CITY OF WEST TORRENS

Notice of Panel Meeting

COUNCIL ASSESSMENT PANEL

TUESDAY, 14 FEBRUARY 2023 at 5.00pm

Figure 7: Overlay Map WeTo/8 - Development Constraints

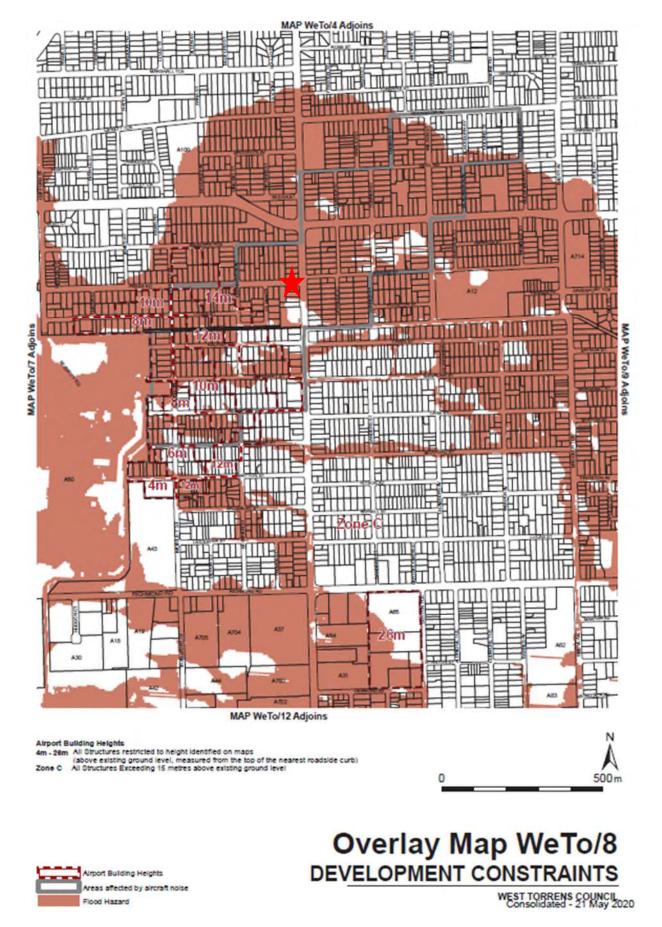
Overlay Map WeTo/8 identifies that the subject land is within an area affected by aircraft noise while also being subject to flooding (see Figure 7 on the following page). In terms of aircraft noise, PDCs 6 and 7 within the 'Building near Airfields' policies of the General Section of the Development Plan provide the following guidance:

It is noted that the application has not provided an acoustic report and has not demonstrated how future development on the proposed allotments can achieve consistency with *AS2021 – Acoustics – Aircraft Noise Intrusion – Building and Siting.* For this reason, it is unclear if the proposed land division can accommodate future dwellings which are able to satisfy PDCs 6 and 7.

Figure 1 - Subject building, viewed from Capper Street

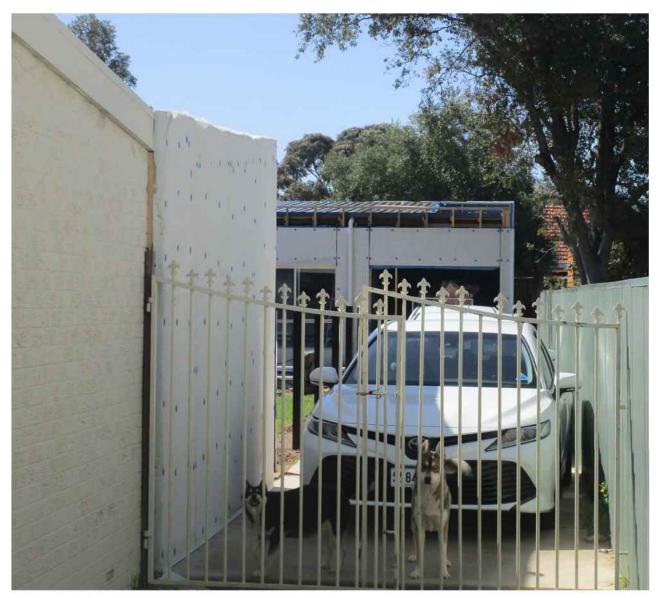
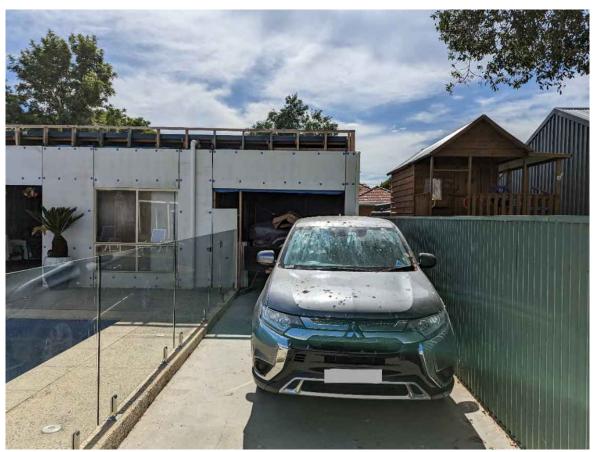
Measuring 123sqm, the floor area of the development represents a departure from that typically contemplated by the Planning and Design Code. This can be seen from neighbouring properties particularly when viewed from the east, where the full length of the building is apparent (refer to Figure 2). The building is not significantly visible from the road frontage as it is located at the rear of the dwelling and 48m from the front boundary. This notwithstanding, the building is located 0.8m from the rear boundary and 0.6m from the southern side boundary. The building spans the majority of the rear boundary and when considered in connection with its overall wall height and appearance, the development is considered to result in poor visual amenity impacts when viewed from adjoining land.

The scale of the building is large in terms of wall height and length and subsequently, the amenity of immediately affected neighbours is compromised by the appearance, bulk and scale of the building. To this end, the development fails to accord with General Neighbourhood Zone, Performance Outcome 11.1. The overall size of the building does not allow sufficient space around the buildings to limit its visual impact and provide an attractive outlook, as sought by General Neighbourhood Zone, Performance Outcome 3.1.

Figure 5: Overshadowing during Winter Solstice (Unit 21 marked with red star)

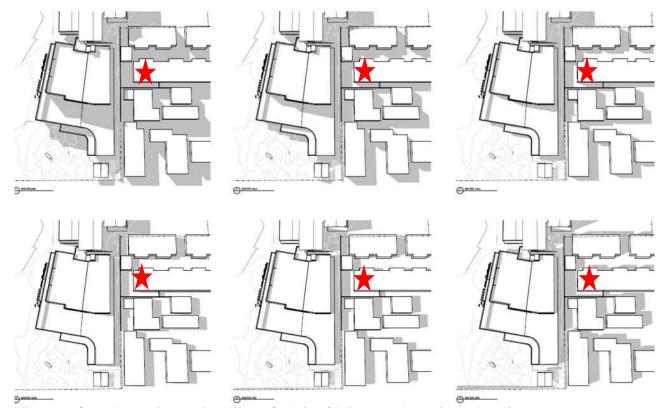
Shadow diagrams provided by the applicant indicate that there will be a degree of overshadowing on some of the adjoining residential properties to the south. In particular, it would appear that the private open space for one of the adjoining units (highlighted by a red star in the figure below) is likely to be the most affected by the proposed development with only a relatively small portion of the private open space receiving direct sunlight during the winter solstice (see Figure 5 below).

The applicant's Planning Consultant has undertaken a detailed review of the overshadowing impacts and has provided the following commentary in relation to the impact on the private open space of the property highlighted with a red star in Figure 5 (Unit 21):

While the increased overshadowing caused by the proposed two-storey building is not ideal, it is noted that the proposal only slightly falls short of the guidelines within DTS/DPF 3.2. More specifically, DTS/DPF seeks direct sunlight to at least 35m² of private open space, while the shadow diagrams indicate that only 25m² will receive direct sunlight during the winter solstice. Given that the proposed development generally satisfies the majority of other provisions of the Planning and Design Code (including setbacks from boundaries), a shortfall of approximately 10m² in terms of overshadowing of private open space is considered acceptable. Therefore, the development is considered to satisfy Interface between Land Uses POs 3.1 and 3.2 even though it falls slightly short of DTS/DPF 3.2:

Figure 1 Ground and upper floor setbacks from the western boundary shared with the Clyde Avenue representors (15-21 Clyde Avenue)

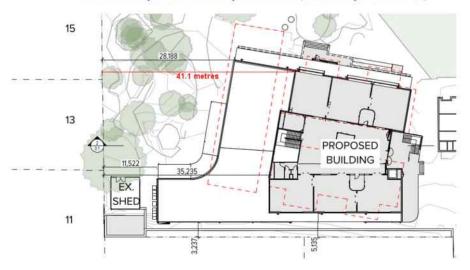
The Code seeks to minimise "direct overlooking" from upper levels of nearby windows and private open space. Direct overlooking is not defined in the Code but is commonly understood to include views within 15 metres of a window and within a 45" arc each side of the centreline of the window. In this case, direct overlooking is mitigated by both the distance and the angle of view.
